AL SUMELAT
WATER NETWORK
VILLAGE OF AL SUMELAT, IRAQ

SIGIR PA-05-004
MARCH 15, 2006

Al Sumelat Water Network Village of Al Sumelat, Iraq Synopsis

Figure 1: Al Sumelat Pipeline Location Map

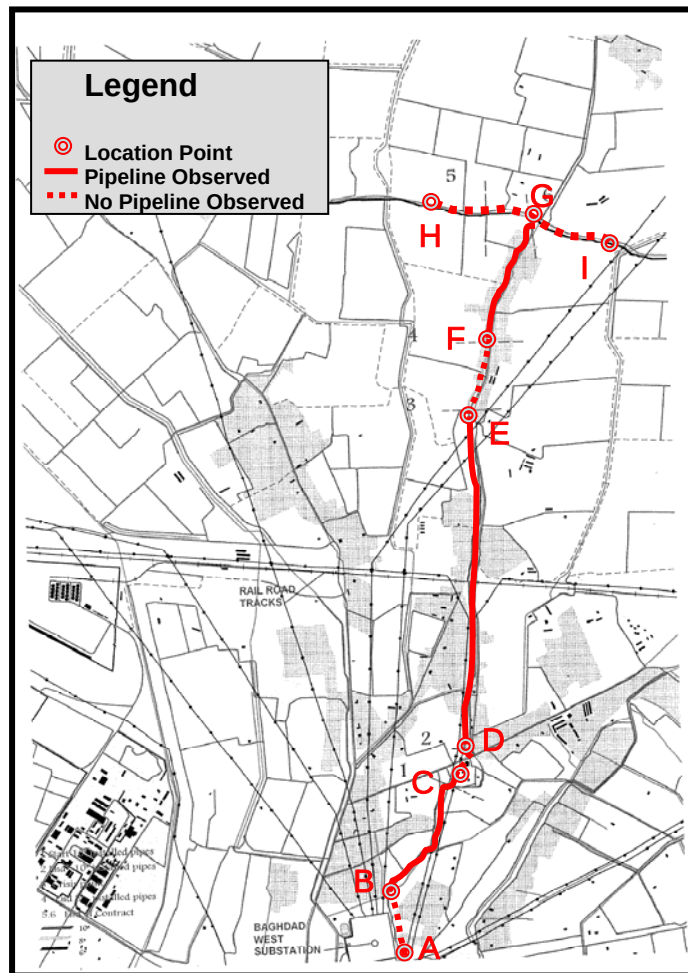
2. The contractor's design was inconsistent with the requirements of the contract and inadequate for the project. The pipeline route and location of valves and tees were not adequately identified. In addition, design of the pipeline route under structures, such as railroad tracks, roadways, and irrigation canals was incomplete.

Point A to B: The approximate length of the pipeline from point A to point B (see the locator map in Figure 1 on page 4) is 840 meters. Disturbed soil leading in the direction of the pipeline route was observed from point A. The disturbed soil appeared to be the result of a recent trench excavation and subsequent backfilling of the trench (Site photo 2). It could not be determined how far this excavation continued. The starting point of the pipeline was not visibly protruding from the disturbed soils and could not be located at point A. An observation at point B leading back toward point A along the proposed pipeline path was of an open field showing no recently disturbed soil (Site photo 3). Consequently, no evidence that the pipeline had been installed between points A and B was found.

Point B to C: The approximate length of the pipeline from point B to point C (see the locator map in Figure 1 on page 4) is 1,495 meters. Uncapped endpoints of the pipeline were observed at both points B and C (Site photos 5 & 6). The pipe diameter looked to be approximately 225 millimeters, but accurate measurements were not obtained at this location. Disturbed surface soil was observed continuously between points B and C along the proposed pipeline route. The disturbed soil appeared to be the result of a recent trench excavation and subsequent backfilling of the trench. A sand base was not present at the endpoints of the pipeline. A significant amount of unconsolidated soil was observed above grade along the pipeline path. Lack of compacting during backfilling operations would result in the presence of the observed excess soil. The surface of the disturbed soil was uneven with several feet variation in height along the pipeline route. This indicates that final surface grading was not completed. It appeared, based on site assessment observations, that the pipeline had been installed between points B and C, but the pipeline installation was not consistent with contract requirements.

Point D to E: The pipeline leg from point D to point E (see the locator map in Figure 1 on page 4) is approximately 3,389 meters in length. This section parallels the road and crosses underneath a set of railroad tracks. The endpoint could not be located at point D and an uncapped endpoint of 225 millimeter diameter pipeline was observed at point E. Disturbed surface soil was observed continuously between points D and E along the proposed pipeline route. The disturbed soil appeared to be the result of a recent trench excavation and subsequent backfilling of the trench. A sand base was not present at the endpoints of the pipeline. A significant amount of unconsolidated soil was observed above grade along the pipeline path. Lack of compacting during backfilling operations would result in the presence of the excess soil. The surface of the disturbed soil was uneven with several feet variation in height along the pipeline route. This demonstrates final surface grading was not completed. It appeared, based on site assessment observations, that the pipeline had been installed between points D and E, but the pipeline installation was not consistent with contract requirements.

Point H to I: The pipeline leg from point H to point I (see the locator map in Figure 1 on page 4) is approximately 2,571 meters in length. A recently dug open trench approximately 1 meter in depth was observed along the proposed pipeline route. Pipe was not visible and the bottom of the trench excavation appeared to be undisturbed soil. Consequently, no evidence that the pipeline had been installed between points H and I was found.
